Groundwater Application Review Summary Form

Application # G- 19425

PUBLIC INTEREST REVIEW FOR GROUNDWATER APPLICATIONS

A. GENERAL INFORMATION: Applicant's Name: Warrick Vineyard, LLC County: Jackson

Theis Interference Analysis

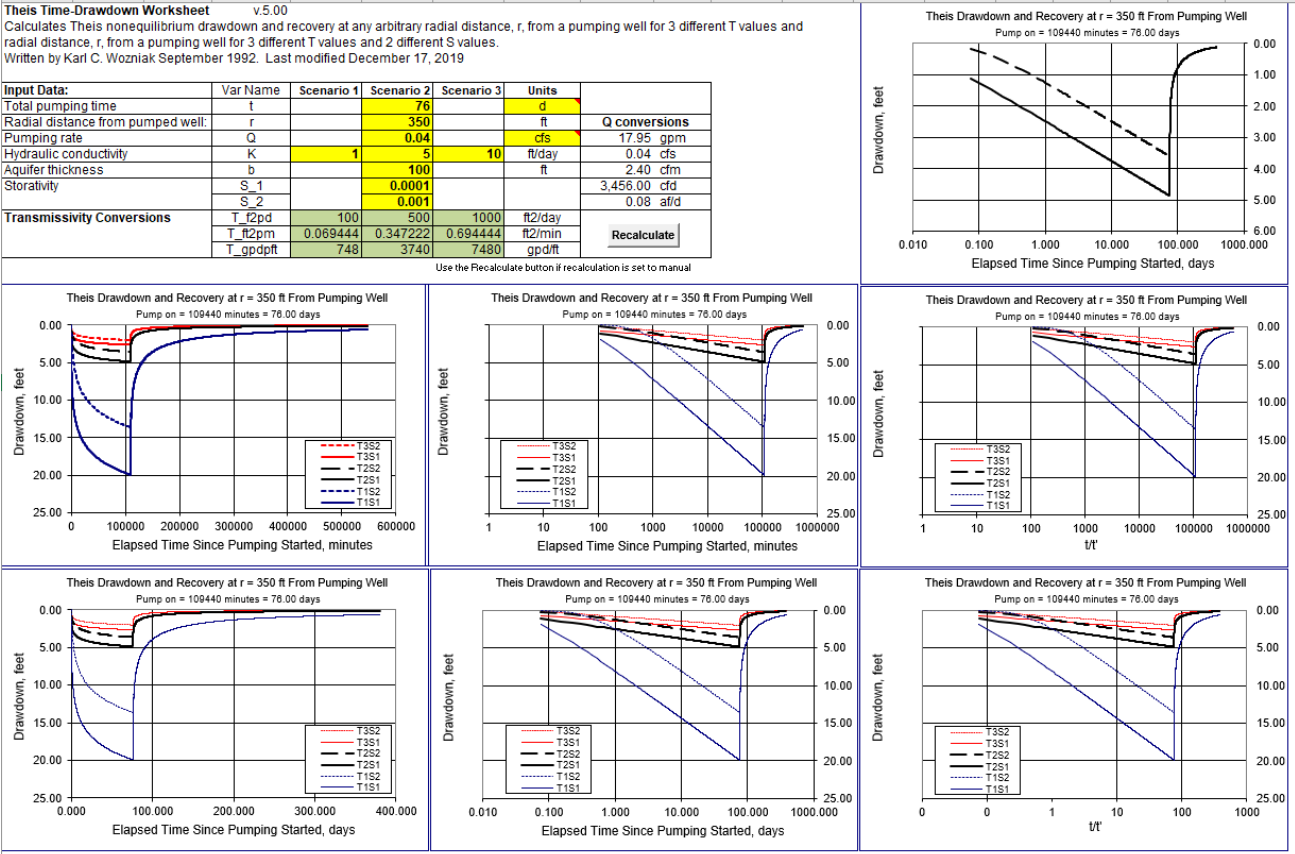
There are several groundwater rights within 1 mile and several residential properties on adjacent tax lots that are likely supplied by exempt use groundwater wells. A Theis (1935) drawdown analysis was conducted to assess potential well-to-well interference at the closest residential property (Tax Lot 1400), located approximately 350 feet west of JACK 14443. Hydraulic parameters used in the Theis analysis are based on pumping tests for nearby wells and are within the typical range of values for the hydrogeologic regime (Freeze and Cherry, 1979). To be conservative, the analysis assumed JACK 14443 would be pumped continuously at the maximum requested rate (0.04 cfs) until reaching the requested annual volume of 6 acre-feet, which would take approximately 76 days. Results of the Theis analysis indicate drawdown at adjacent residential properties would likely not exceed 10 feet as a result of the proposed use at JACK 14443 (see attached Theis Interference Analysis). The magnitude of well-to-well interference is difficult to predict for fractured-bedrock aquifer systems but based on the relatively low requested pumping rate, it is unlikely that the proposed use would result in injury to other permitted groundwater rights or exempt use wells.
